**ADDENDUM NUMBER 9**  
HILLSBOROUGH COUNTY DEPARTMENT OF PROCUREMENT SERVICES  
P.O. BOX 1110  
TAMPA, FLORIDA 33601

**BID TITLE: Design/Build of School Safety, Circulation and Access Program**

1. Issue questions/answers.
2. Issue Pavement Cross section and Typical Pavement Sections plans.
3. Shortlisted firms will be notified of Oral presentation date/time at a later date.

CONCEPTUAL PLANS OF PROPOSED GROUP "B" SCHOOLS

Pavement Cross section

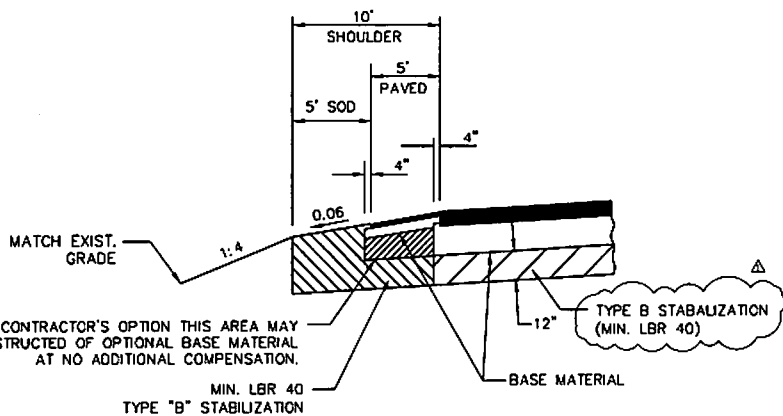
2. **Question:** Bellamy, Leto, Northwest, and Twin Lakes – The widening pavement structure (type II) includes the use of 1” of FC-9.5 friction course, and the milling and resurfacing detail shows the use of 1.5” of FC-12.5 friction course. Is it the County’s intention to use two different types and thicknesses of friction course adjacent to one another?

1. **Question:** The changes made in the Group B schools for pavement for on-site improvements result in a Structural Number (SN) of 4.0 and the off-site paving SN is 4.9. These are very high numbers/requirements compared to other County roadway projects (for example, Lutz Lake Fern Rd. project SN=4.3 by true pavement design/traffic calculations) as well as the County's 2009 Transportation Technical Manual (min. SN=2.3 local residential roads and min. SN=2.5 for all other classifications) which applies to subdivisions and private development on-site roadways. The Group A school pavement design in the concept plans range from a 2.65 SN (min.) for Boyette Springs Elementary to an SN of 3.85 for pavement widening on off-site collector roadways. It is not clear why there is a large difference between the Group A and Group B school pavement designs.

**Answer:** The Friction Course FC-9.5 has been revised to FC-12.5 for all Type II Pavement Sections. Please refer to Conceptual Plan Revision #2. The Friction Course layer thickness has been updated accordingly.

**Answer:** For consistency and to allow the Design-Build Team the option, the pavement sections for the Group B school sites have been revised to FDOT Optional Base Group designations. Since the County's Transportation Technical Manual does to allow for a Base Course (including asphalt) thickness of less than 8" for Collector Roads, the Design-Build Team's are not required to follow the TTM for pavement criteria. Refer to Group B Plans Revision #2.

**SHOULDER PAVEMENT DETAIL**  
(N.T.S.)

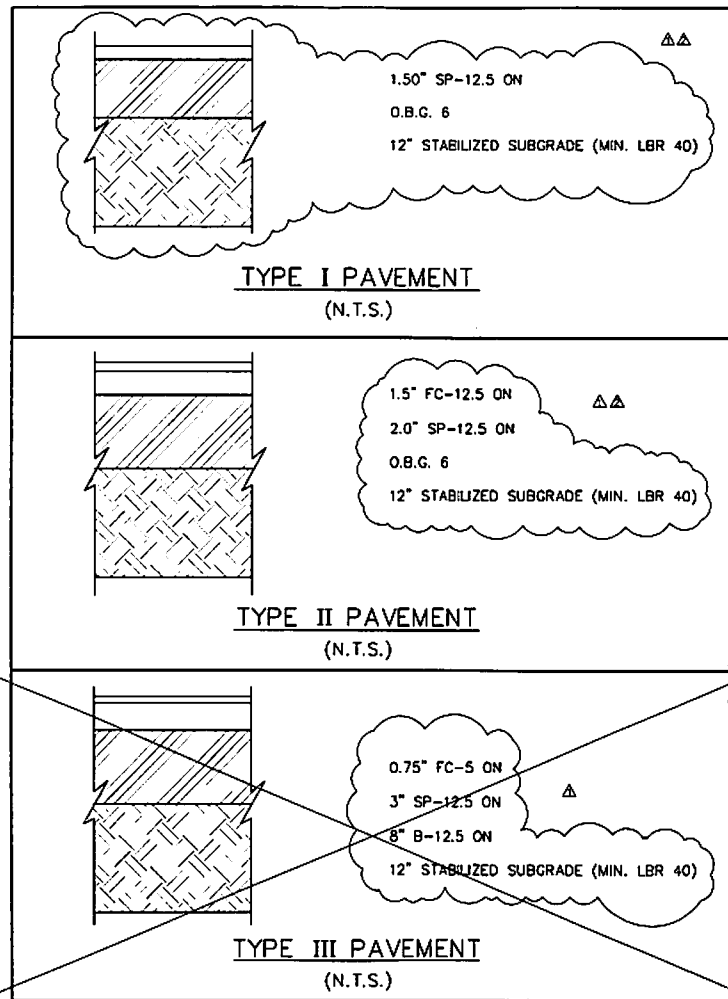
3. **Question:** Carrollwood, Leto – The shoulder pavement structure includes the use of 1.5” of FC-12.5. The widening pavement structure for Carrollwood does not include friction course, and the widening pavement structure for Leto includes 1” of FC-9.5 friction course. Is friction course required for these shoulders? If so, shouldn’t the type and thickness of the friction course match that of the adjacent lane?

3. **Question:** If paved shoulders are req'd. - what is the required pavement structure as there is none indicated in the Group A concept plans (but there is a pavement structure included in the Group B plans)?

**Answer:** Per Conceptual Plans Revision #1, the Carrollwood school site was updated to Type II Pavement Section. Per Revision #2, the Leto school site Type II Pavement Section has been revised from FC-9.5 TO FC-12.5. Friction Course is required for the shoulders (See Revision #2).

**Answer:** The required pavement structure for paved shoulders should be in accordance with the shoulder pavement detail shown on sheet 9 of the Conceptual Plans of Proposed Group "B" Schools prepared by KING ENGINEERING.

1.5" FC-12.5 ON  
1.5" SP-12.5 ON  
O.B.G. 4 ON  
TYPE "B" STABILIZATION (MIN. LBR 40)
